ARCHITECT'S FIELD REPORT

PROJECT	Village Center Remodel	DATE	11/1/19
	Emmons Building, 600 Gothic Road		
	Axtell Building, 22 Snowmass Road

Engineer's field report

Project: Village Center Remodel

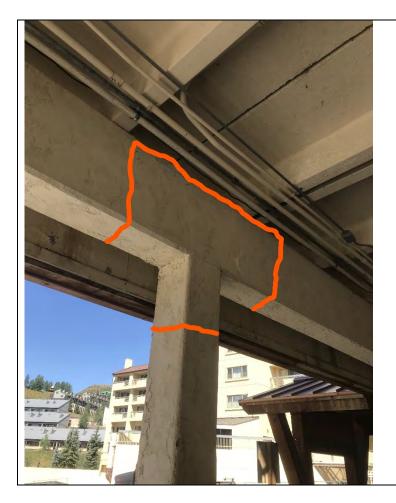
Photo	Description	Action
	North Emmons beam bearing location requiring structural investigation. Stucco has been removed in a small location by beam. Area outlined in red must be stripped down to wood sheathing.	Selective demolition
